## **USA POB SUBDIVISION**

APPLICATION NUMBER 12 DATE July 17, 2014

REQUEST Subdivision

# DETAIL SITE PLAN

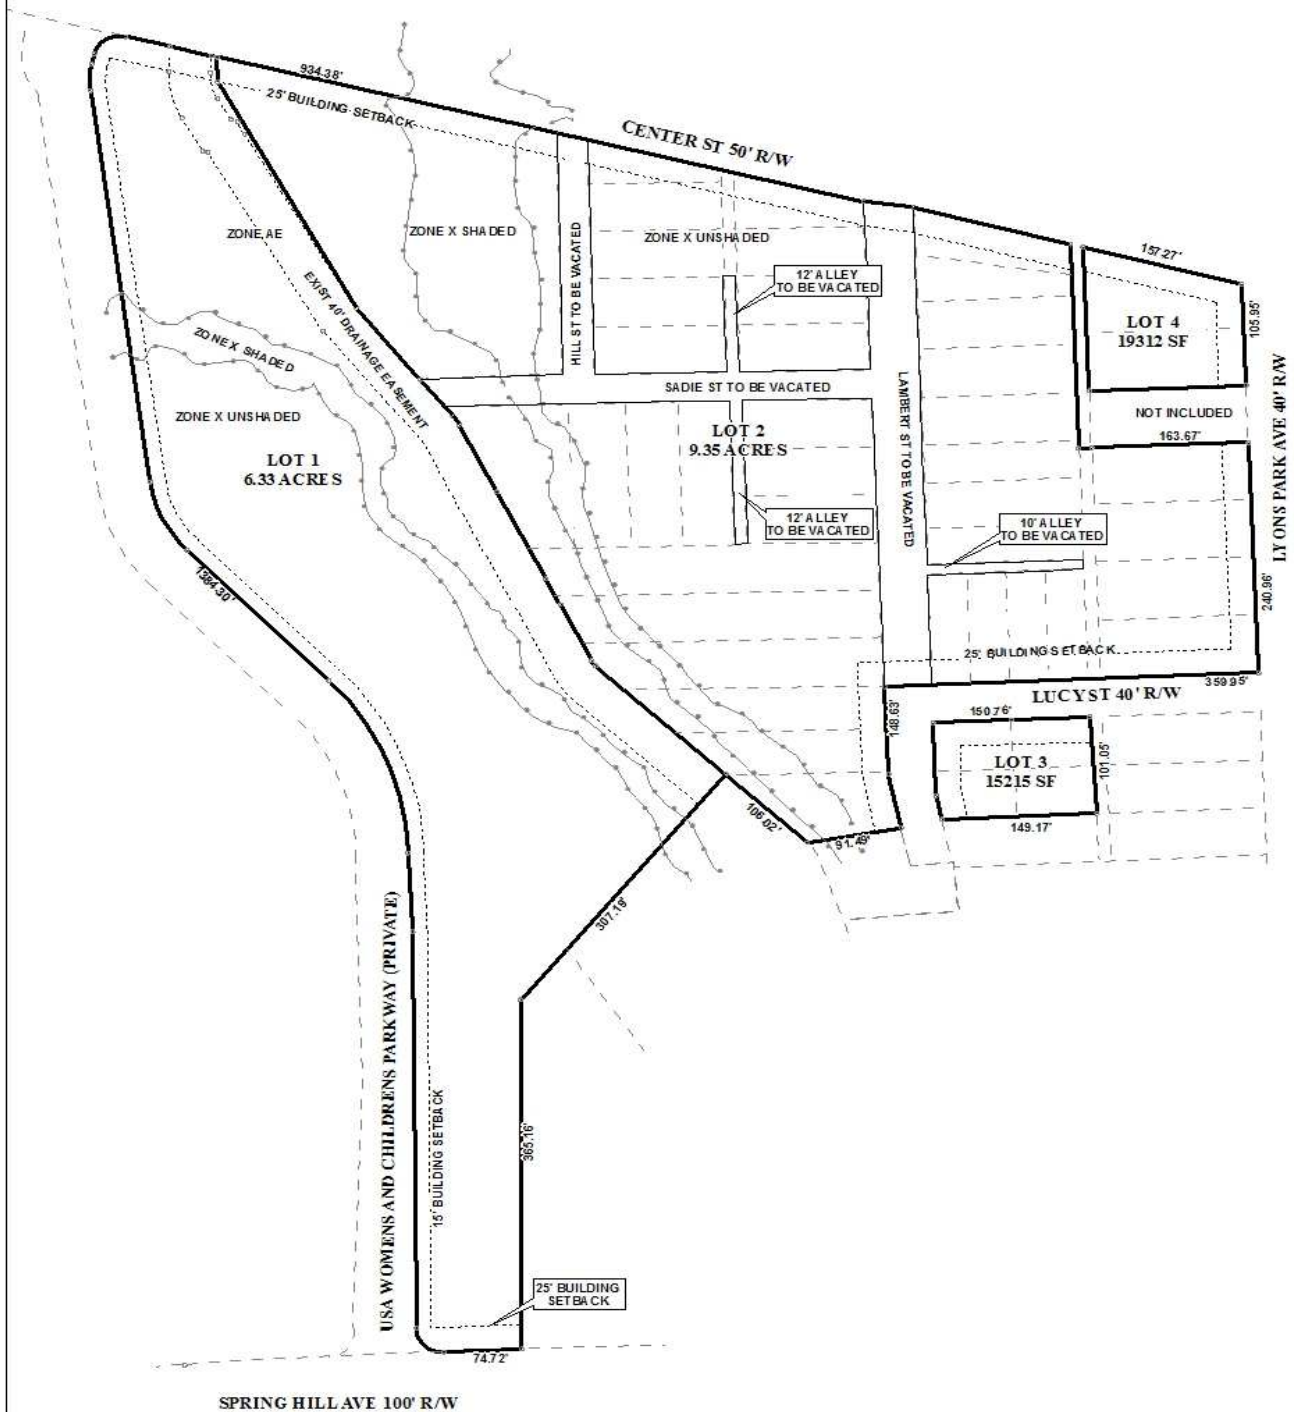
- D. Provide dedication of the corner radius (25' minimum or as approved by the City Engineer and Traffic Engineer) at the northeast corner of LOT 4 (Center St. and Lyons Park Ave.), and the southeast corner of LOT 2 (Lyons Park Ave. and Lucy St.).

- E. Show and label the MFFE (Minimum Finished Floor Elevation) on each lot that contains an AE, V, or X (shaded) flood zone designation.
- F. Add a minimum 15 ft. wide access easement parallel to the existing drainage ditch and easement; and an access point off of the southern portion of Lambert St.

- L. Show the recording information for the vacated ROW and alleys. Clarify the labeling of "...to be vacated" shown on the plan and "...now vacated..." shown in part of the legal description.

The site has frontage along multiple streets: Spring Hill Avenue, USA Children's and Women's Parkway, Center Street, Lyons Park Avenue, Lucy Street, and Lambert Street. The existing right-of-way width for all streets is sufficient as the site is composed of existing lots; however, the proposed Lots 1 and 2 will require a waiver of Section V.D.8. of the Subdivision Regulations regarding double frontage lots since the proposed lots have frontage along multiple streets. The provision of a corner radius in compliance with Section V.D.6. of the Subdivision Regulations should also be required along Lyons Park Avenue where it intersects Center and Lucy Streets, and at the intersection of Lucy and Lambert Streets. The lot size information and 25' minimum building setback line should be revised on the Final Plat, if approved.

It should be noted that the plat illustrates a portion of Lambert Street, Hill Street, Sadie Street, and several 12' alleys to be vacated. The Street Vacation process should be completed prior to the signing of the Final Plat, if approved.

It should be pointed out that the preliminary plat depicts a 40' drainage easement along the eastern lot line of the proposed Lot 1. If approved, a note should be placed on the Final Plat stating that no permanent structures can be constructed in any easement.

- 1) Dedication of a corner radius at the intersection of Lyons Park Avenue and Center Street; Lyons Park Avenue and Lucy Street; and Lucy Street and Lambert Street on the Final Plat;

- 2) Revision of the lot size information and the minimum building setback line to reflect dedication, and be retained elsewhere on the Final Plat;
- 3) Placement of a note on the Final Plat stating that no permanent structures can be constructed in any easement;

- 11) *Completion of the Street Vacation process prior to the signing of the Final Plat.*
